PLANNING & DEVELOPMENT
CITY OF NEWARK

The City of Newark's Subdivision Advisory Committee has reviewed the minor subdivision plan for 1025 & 1033 Barksdale Road (PR#21-06-01). We have the following comments:

Figure 3A – Transformer Box Pads

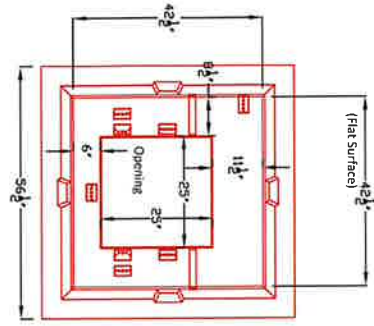
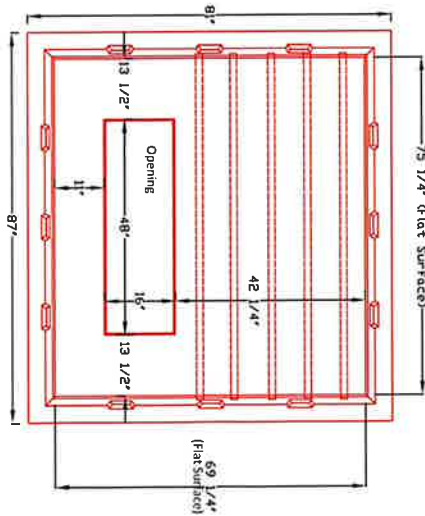
3. The City will supply the transformer pads. The developer shall install the transformer pads per city standards. **(See figure 3a)**
4. If provided, the City will install streetlights only if final landscaping is complete on any adjacent lots.

- NOTE: Contractor should install primary & secondary conduits as far to left & right side of opening.
1. Contractor to dig hole 7"x7"x18" deep.
 2. Contractor to supply and install 3/4" stone.
 3. Machine tamped and leveled, 6" deep.
 4. City to install Box Pad.
 5. Contractor to supply, backfill with select fill.

- NOTE: Contractor should install primary & secondary conduits as far to left & right side of opening.
1. Contractor to dig hole 8.5"x8.5"x18" deep.
 2. Contractor to supply and install 3/4" stone.
 3. Machine tamped and leveled, 6" deep.
 4. City to install Box Pad.
 5. Contractor to supply, backfill with select fill.

Figure 4 - Shrub Clearances Around Transformers

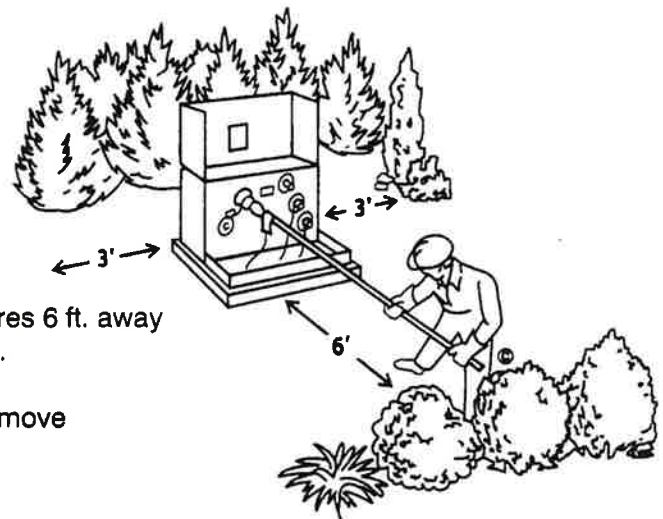
5. No shrubbery shall be installed within six (6) feet of the front of a padmount transformer or three (3) feet on the other sides. **No trees over eighteen (18) feet at maturity shall be planted under any aerial lines. (See figure 4)**

Figure 5 – Meter Box Installation

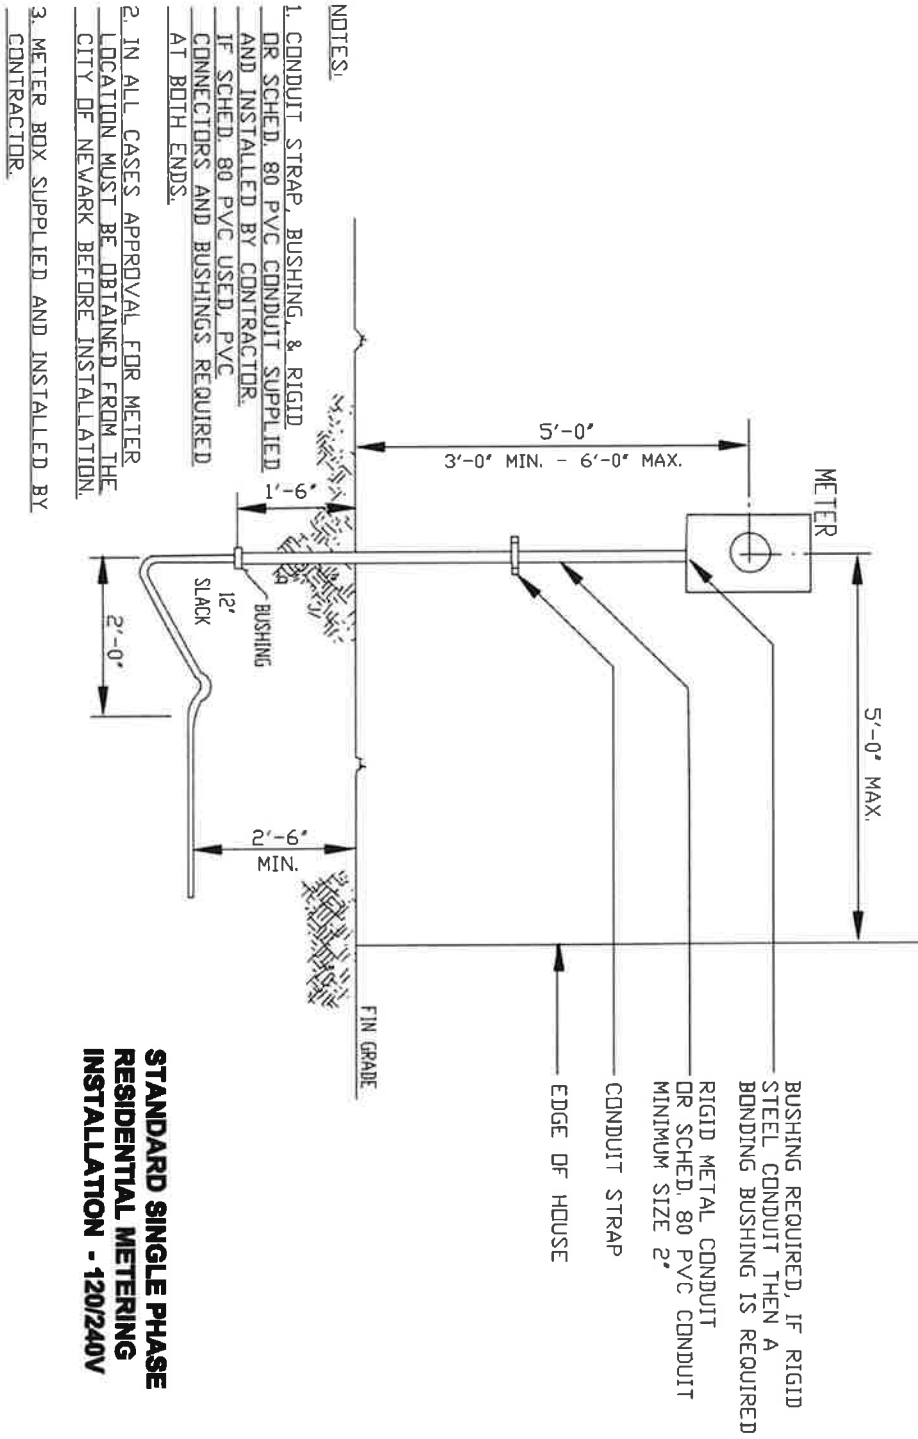
6. The City will install secondary service lateral cables only after the meter box and strapped rigid galvanized steel or schedule 80 PVC conduit are mounted. **(See figure 5)**

4. A **rigid galvanized steel riser or a schedule 80 PVC conduit riser** strapped to the wall and installed eighteen (18) inches below grade with a **plastic bushing** is required (See figure 5). If meter riser conduit is encased in concrete or blacktop a slip-fitting or ground sleeve is required. **No 90-degree elbows should be used at the bottom of the service riser.**

7. Meter box shall be installed at a height of five (5) feet to the center of the box from final grade within five (5) feet of the front corner of the dwelling unless notified otherwise by a City representative (See figure 5).

Figure 8 – Riser Pole Construction

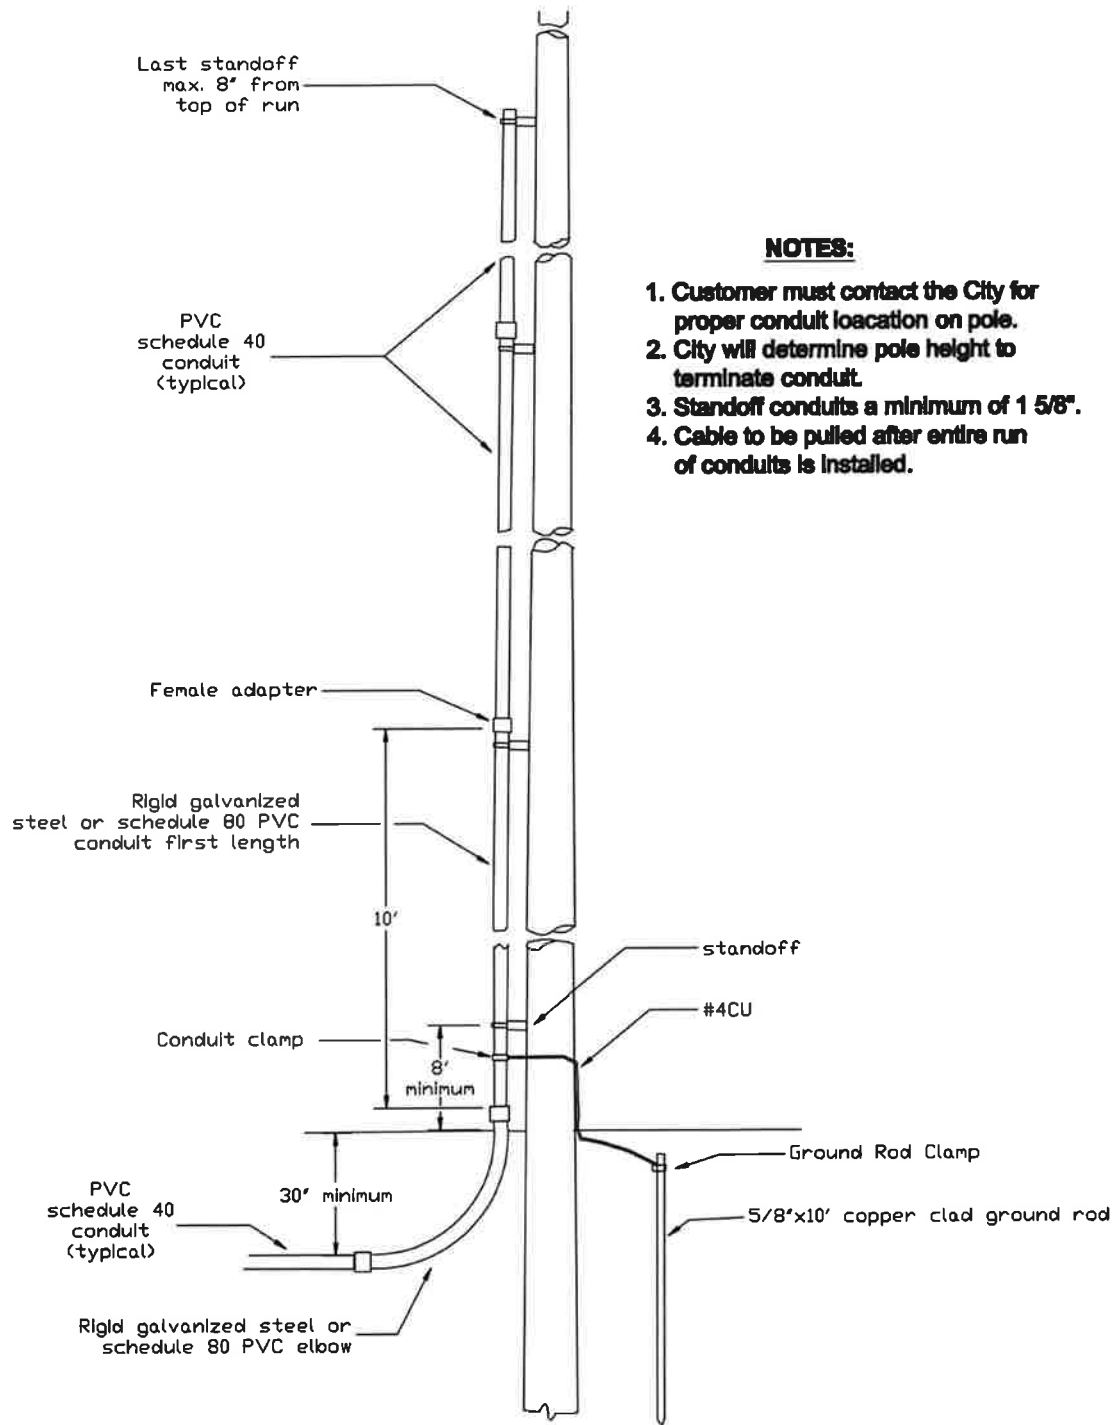
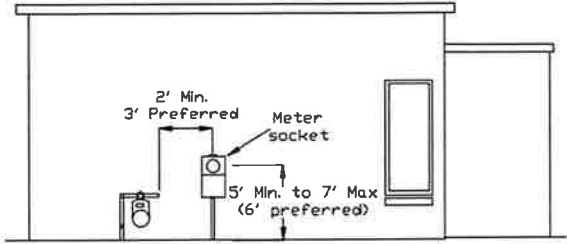
9. The developer shall install conduit a minimum of forty (40) inches deep. A galvanized steel or schedule 80 PVC elbow and ten (10) feet of rigid galvanized steel or schedule 80 PVC conduit is required at the service pole. The rigid steel conduit shall be bonded to the pole ground with a conduit ground clamp. The remainder of the riser conduit may be PVC schedule 40. Customer shall furnish this PVC conduit and standoffs to the City for installation by City crews if existing energized conductors are located on the service pole. Pull string shall be installed prior to building conduit up pole. Customer is responsible for PVC conduit and standoff installation if no existing energized conductors are located on the pole. All conduits shall be stood off pole a minimum of 1+5/8". (See figure 8)

1. Customer must contact the City for proper conduit location on pole.
2. City will determine pole height to terminate conduit.
3. Standoff conduits a minimum of 1 5/8".
4. Cable to be pulled after entire run of conduits is installed.

Figure 17 – Joint Trenching

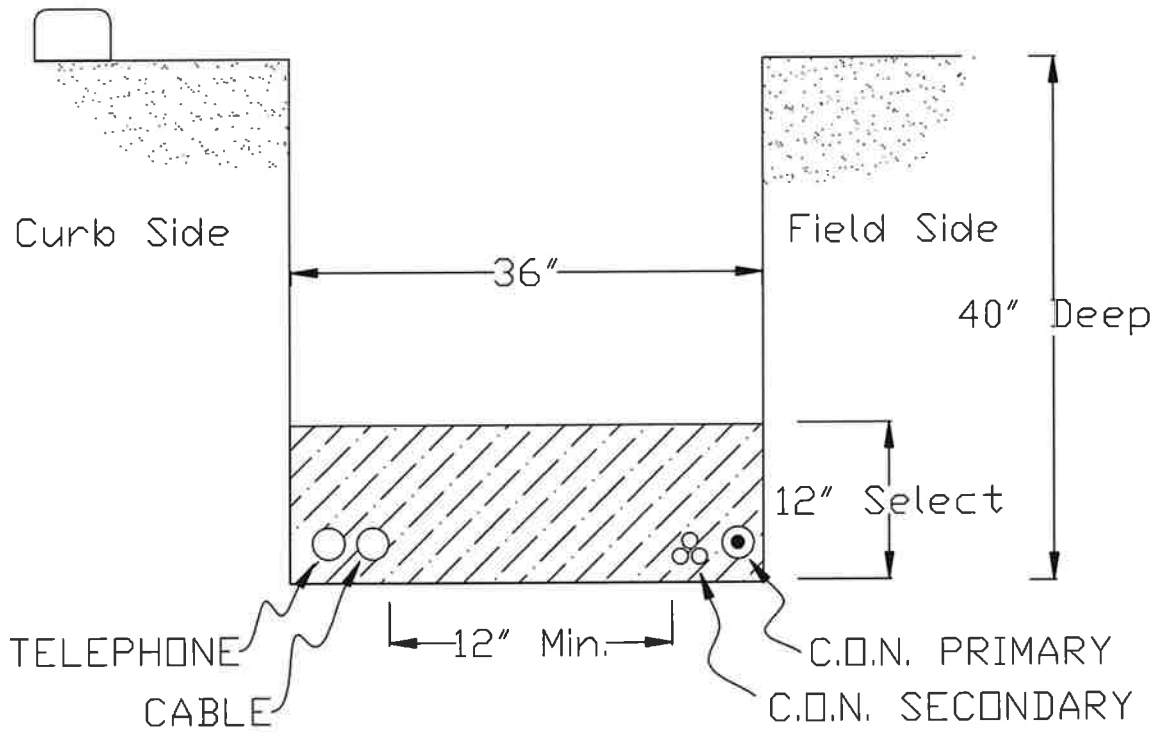
1. Trenches shall be 40" deep. 36" wide. Main line trench shall normally be dug behind the sidewalk. Trench to be backfilled with select material or sand. Fill material shall be verified and approved at a site pre-construction meeting. **(see figure 17)**
